Re: Contract No. 200-2009-28555, SCA-TR-TASK1-0023: *Review of the NIOSH Site Profile for the Argonne National Laboratory - East*

Review of the NIOSH Site Profile for the Argonne National Laboratory - East

**Contract No. 200-2009-28555
Task Order No. 1
SCA-TR-TASK1-0023**

Figure 3: 1-Year Committed Equivalent Dose for Organs due to 1-Year Chronic Intake of Pu-239, in Sv/Bq Excreted in 24-Hr Working Day Urine Samples after 1 Year of Work

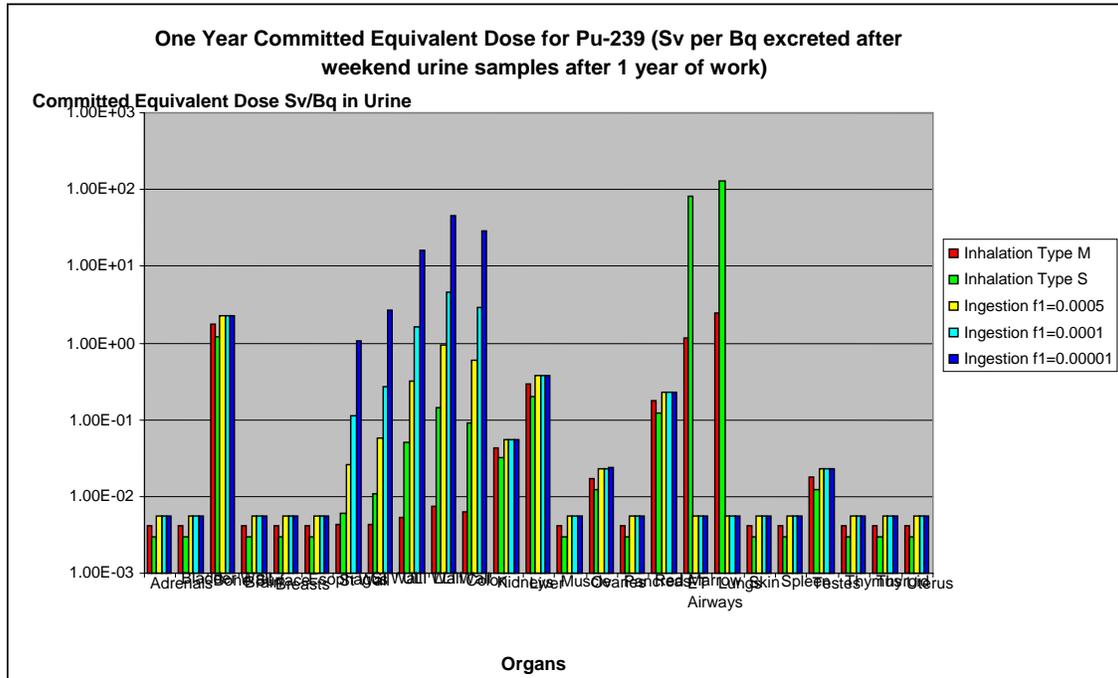
NIOSH needs to provide guidance in TKBS-0036-5 for dose reconstructors to assess this potential missed dose, especially for the insoluble compounds, given that plutonium urine concentrations near the MDC may represent a significant intake and dose. This also applies to other alpha emitters, including uranium and americium.
